**Marge Schmuckal - Re: Drive Cut Request - 53 Brackett St.**

53 BRACKETT ST.  
DRIVEWAY CUT REQUEST  
MATT DiBIAS - MATTE.LANDINGHOMESMAINE.COM  
653-0376

<b>PROPOSED CURB CUT</b>		
Project Name and Location		
63 BRACKETT STREET		
PORTLAND, MAINE 04112		
DATE: FEBRUARY 14, 2013	SCALE: 1" = 20'	1 0 1

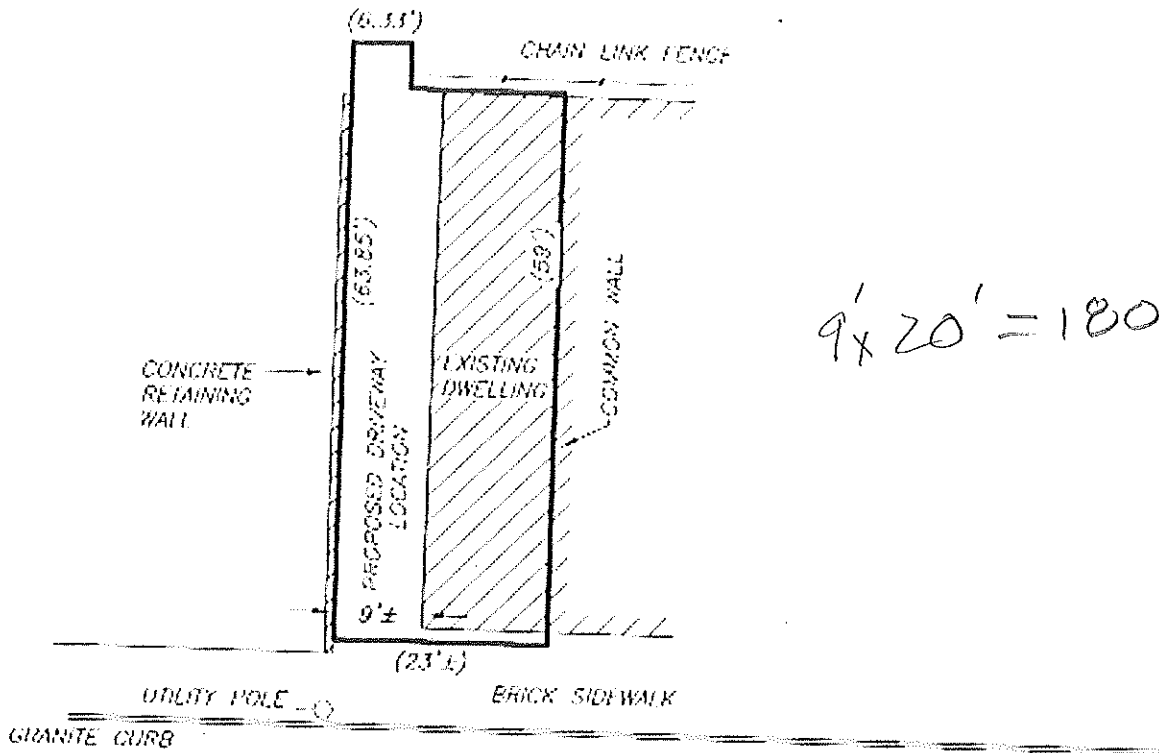
Sorry to take so long to get you a formal response, but this was difficult and this drive cut does require a waiver from our standards because the width you propose does not meet the minimum ten foot width for a driveway.

This is an extremely tight site and the utility pole is an additional obstacle.

The City is aware parking issues in the city and we try hard to accommodate when possible. In this case we are agreeable to grant a curb cut width waiver to install a curb cut for this location with the following understanding.

1. A fence be installed along the side property line to avoid encroachment onto the abutting property prior to issuing a Street Opening Permit for this work.
2. Once the decision has been made to do this work, contact myself or John Low (653-8064) to schedule a site meeting to review all city requirements and scope of work prior to contacting contractors or obtaining a Street Opening Permit.
3. That this email be considered as your official notice of approval for a drive cut at 53 Brackett St and as shown on the attached drawing.
4. That all information contained in this email be passed along to any new owners of this property.
